Product Change Notification

PCN ID: 3A01

Description/ Purpose of change	HI-POT test screw indicator on enclosure			
Article category	DIN-Rail DRB3 series			
Change category	Form	Fit	X	Function

Previous state	New state
Description		
Revision	D06	D07

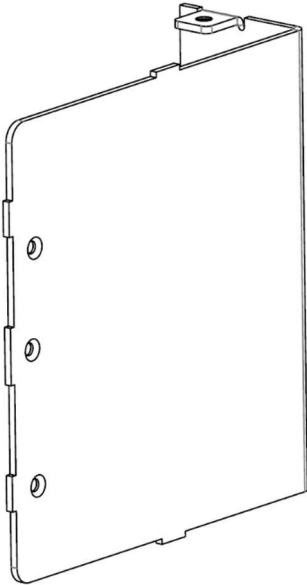
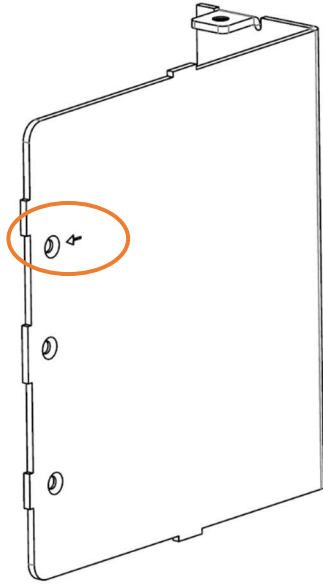
Series	DRB3
Part numbers	DRB120-12-3-A0, DRB120-12-3-A1, DRB120-24-3-A0, DRB120-24-3-A1, DRB240-24-3-A0, DRB240-24-3-A1, DRB240-48-3-A0, DRB240-48-3-A1
Change	Additional engraving on the enclosure to indicate the ground connection screw of the GDT (gas discharge tube). In case of a field HI-POT test the screw must be disconnected. The detailed instruction can be found on the technical product specifications under chapter 13.3.

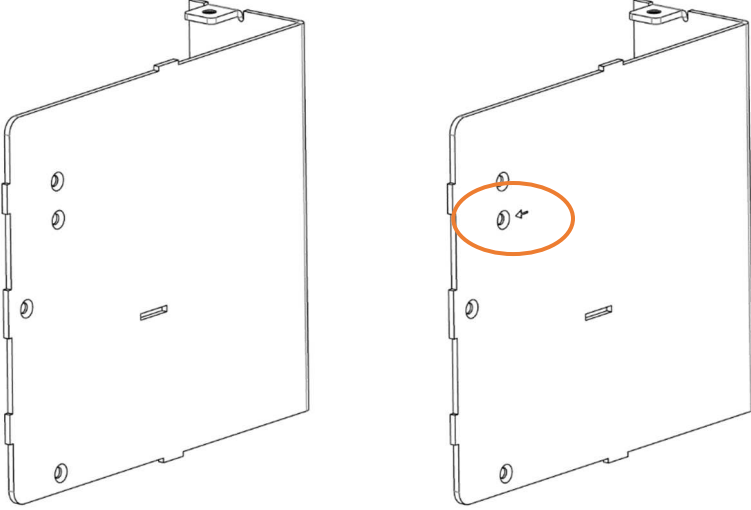
Series	DRB3	
Part numbers	DRB480-24-3-A0, DRB480-24-3-A1, DRB480-48-3-A0, DRB480-48-3-A1	
Change	Additional engraving on the enclosure to indicate the ground connection screw of the GDT (gas discharge tube). In case of a field HI-POT test the screw must be disconnected. The detailed instruction can be found on the technical product specifications under chapter 13.3.	
	Previous state	New state
Description		
Revision	D01	D02
